STAFF REPORT

File Number	PL 15-183	Contact	Jenn Reed Moses, jmoses@duluthmn.gov	
Application Type	Preliminary Plat, Morgan Park Estates	Planning Commission Date	January 12, 2016	
Deadline for Action	Application Date	December 22, 2015	60 Days	February 20, 2016
	Date Extension Letter Mailed	December 22, 2015	120 Days	April 20, 2016
Location of Subject	1243 88th Avenue W (former Morgan Park School)			
Applicant	Aaron Schweiger	Contact	schweiger.aaron@gmail.com, 612-735-9481	
Agent	David Bolf	Contact	david@nce-duluth.com, 218-727-5995	
Legal Description	See attached			
Site Visit Date	August 24, 2015	Sign Notice Date	December 29, 2015	
Neighbor Letter Date	N/A	Number of Letters Sent	N/A

PRELIMINARY PLAT OF MORGAN PARK TOWNHOMES

Proposal: Concept Plan for Morgan Park School Site

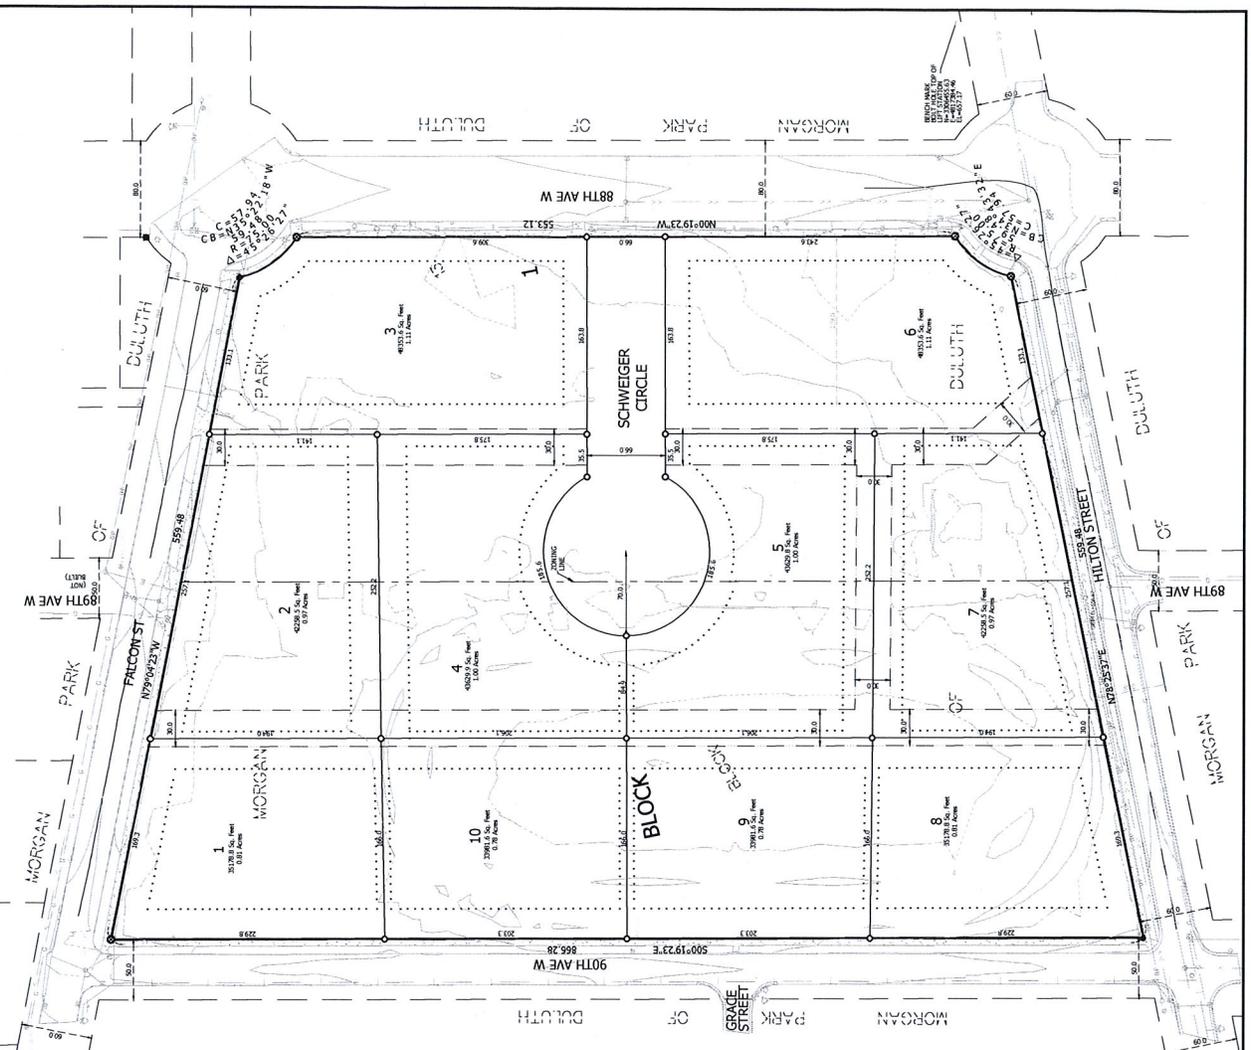
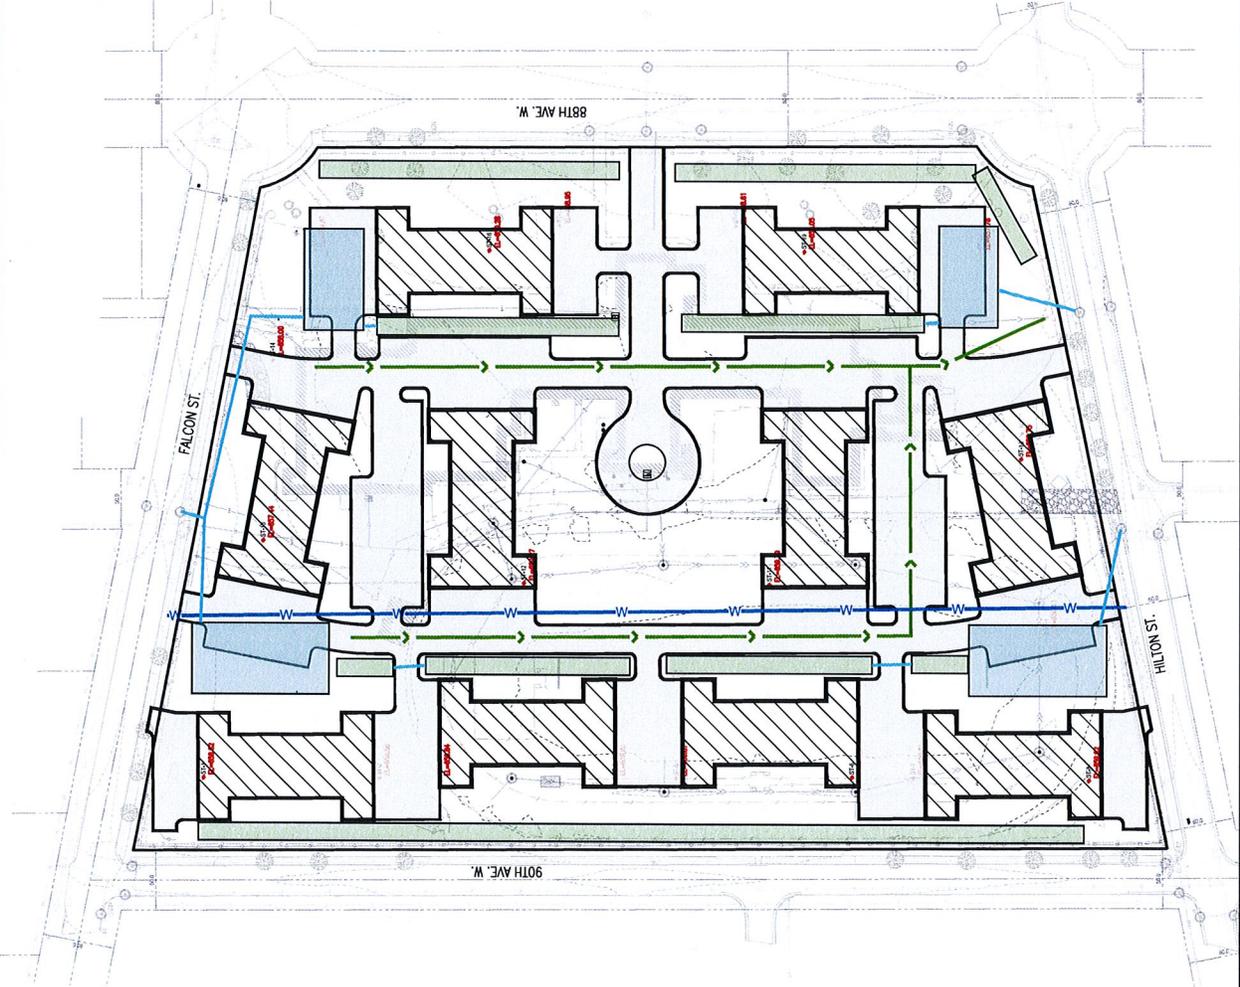
- 1.) The applicant is proposing to subdivide the property to prepare for future apartment buildings.
- 2.) The applicant completed the first step for a subdivision, a concept plan, in December 2015. One item from the Concept Plan remains outstanding: the need for a pedestrian easement from the end of the cul-de-sac to 90th Avenue W.

- 4.) When the street is developed, a sidewalk at least 5' wide will be required on both sides of the street. The UDC requires a pedestrian access from the end of a cul-de-sac to the adjacent street, and also requires a pedestrian way near the middle of any block face longer than 800 feet -- both of which apply to this subdivision. Staff recommends that approval of the preliminary plat be issued with a condition that a minimum 10' pedestrian easement be dedicated, and a pedestrian sidewalk or trail built, from the end of the cul-de-sac to 90th Avenue W.

- 1) A pedestrian easements be dedicated from the end of the cul-de-sac to 90th Avenue W, with the understanding that a sidewalk or trail will be developed at the time the adjacent buildings are constructed.

Preliminary Drainage Report Summary (12/14/15) – Morgan Park Estates

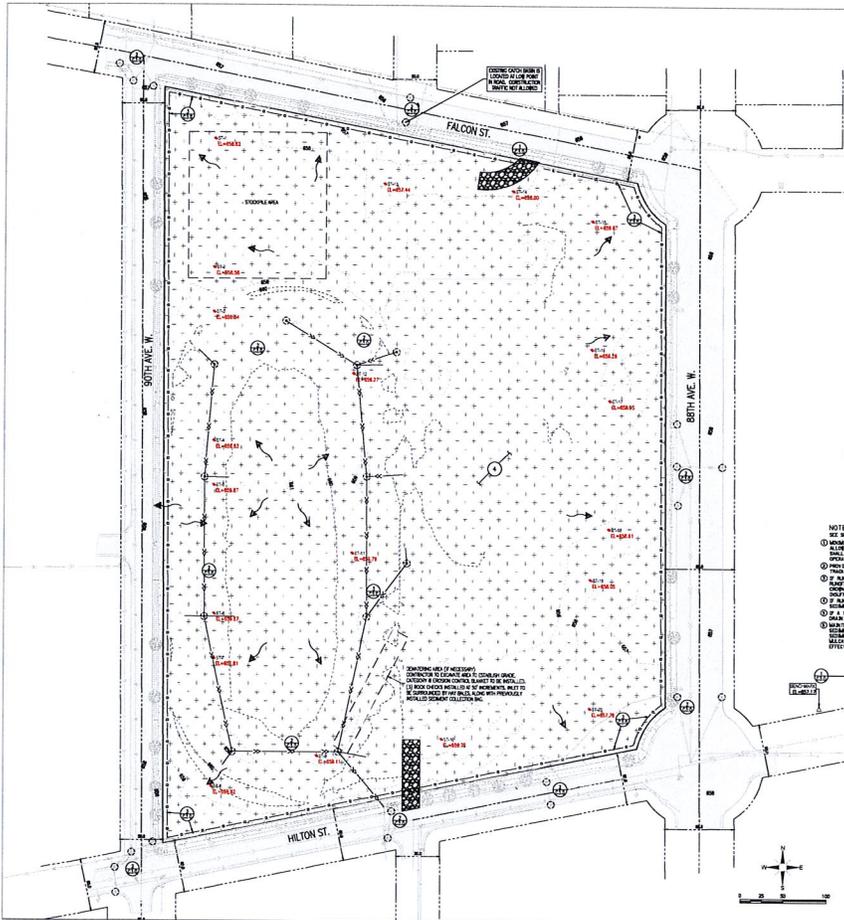
- 3.) Applicant has also submitted a preliminary storm water plan, as required, which has been approved by City Engineering. A full drainage report will be required prior to development.
